## Customer Service Bulletin Commercial Business Group

### Workman® 1100/2100 Series

**Subject: Updated A-Arm Setting Criteria and Procedure.**

## A-Arm Setting Criteria and Procedure for Workman 1100/2100 Series

Figure 3

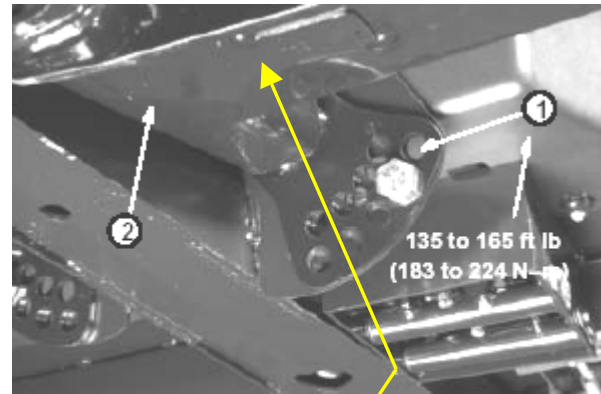
1. Look under each A-Arm for a serial tag and find numbers between 200 and 400 written next to the serial tag. These numbers reference the hole numbers into which the A-arm retaining bolts should be placed. (figure 3)

2. Rotate the front A-Arm to the desired position (refer to the note below) and replace the Ride Height adjustment bolt. Follow procedures in the Service Manual to remove A-Arm bolt.

**The A-Arms are made with rubber bushings inside and have different spring rates. Because of the different spring rates, the A-Arms come adjusted from the factory based on that spring rate. Generally the adjustment bolts will be installed in hole number 2, 3, or 4. These setting may be different from the left side to the right side.**

200 ~ 220 lbs. – 4<sup>th</sup> hole  
225 ~ 285 lbs – 3<sup>rd</sup> hole  
290 ~ 400 lbs – 2<sup>nd</sup> hole

Each hole equals about 3/4 in. (19 mm) of ride height adjustment at the wheel. Always check and re-adjust to the next highest hole number on each side if you are adding heavy attachments or carrying heavy loads often.
